REQUEST FORM FOR DIVISIONAL APPLICATION UNDER 37 CFR 1.53(b)

DOCKET NUMBER: 085393-0808

This is a Request for filing a Divisional application under 37 CFR 1.53(b) of pending prior application

No. 13/037,831, filed on March 1, 2011, entitled **SEMICONDUCTOR DEVICE**, by the following named

FIG. 3C

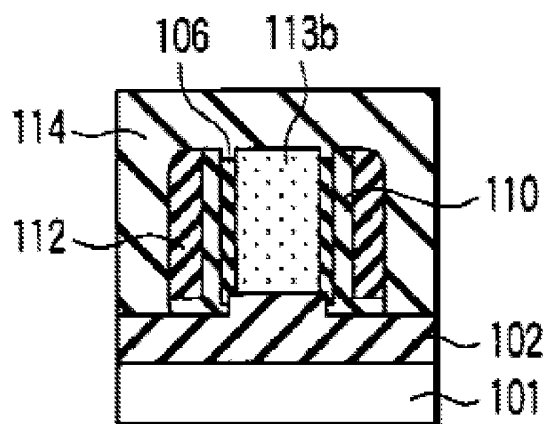
Claims 21-25 and 27-33 are rejected under 35 U.S.C. 102(e) as being anticipated by Hieda et al. (U.S. 6,992,358).

Hieda discloses, as shown in Figure 3C, a semiconductor device with

(21) a gate insulating film (102) formed on an active region in a substrate (101) and including Hf;

an end of the gate insulating film (102) under the insulating sidewall (106, 110, 112) is located to retract from an outer end of the insulating sidewall (106, 110, 112) toward the gate electrode (113b) (see column 9, lines 40-64. Figure 3C);

(22) further comprising a buffer insulating film formed of a silicon oxide film and provided between the substrate and the gate insulating film (see Figure 3C);

(25) wherein a part of the gate insulating film located under the insulating sidewall includes a notch at the end thereof (see Figure 3C);

(27) wherein an end of the gate insulating film protrudes from a side end of the gate electrode toward the insulating sidewall (see Figure 3C);

(28) wherein the insulating sidewall has a double layer structure including an oxide film and a nitride film (see Figure 3C);

(29) wherein the insulating sidewall has a triple layer structure including a first oxide film, a nitride film and a second oxide film (see Figure 3C);

(30) wherein a width of a bottom surface of the gate insulating film along a gate length is larger than a width of a bottom surface of the gate electrode along the gate length (see Figure 3C);

(31) wherein the end of the gate insulating film located under the insulating sidewall has a tapered surface (see Figure 3C);

(32) wherein the gate insulating film located under the insulating sidewall has a thickness which becomes smaller toward the end thereof (see Figure 3C);
